Final Report of the Plutonium Disposition Red Team

Date: 13 August 2015

Thom Mason, Chair

Figure 2. Impact of Arbitrary \$100M and \$200M Reductions in Ops Costs on MOX Program Life Cycle Costs

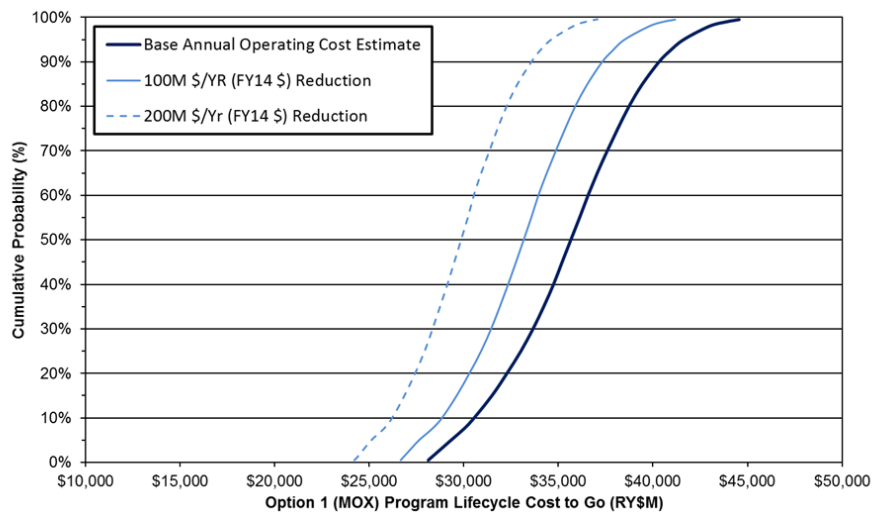
A similar impact was noted from the inflation of predicted operating costs. As can be seen from Figure 2, removing excess contingency from the MFFF operating cost estimates to bring them into better alignment with the MOX Services original estimate (~\$330M/yr, FY14 dollars) and benchmarks at the reference plant (MELOX ~\$250M/yr, FY14 dollars) and the British Sellafield MOX Plant (~\$200M/yr, FY14 dollars) reduces the overall LCC estimate for the MOX option between \$2B and \$10B. Correction of the overly protracted construction and commissioning durations and implementation of a less conservative escalation rate would decrease the LCC estimate for the MOX option even further. These examples highlight the problem with accurately estimating LCCs for multiple decade programs. Uncertainties in key input assumptions can significantly skew the results due to the dominance of escalation. This problem becomes particularly acute when funding constraints or limitations are imposed, especially when funding does not escalate but cost does. The Red Team concludes that the quantitative approach taken by Aerospace significantly overestimated the duration of the MOX facility to reach CD-4, thereby artificially inflating the LCC cost impacts of potential funding constraints. The net result was that conclusions regarding the viability of the MOX approach drawn by Aerospace could be mitigated by decisive Departmental action and consistent Congressional funding at a more appropriate level.
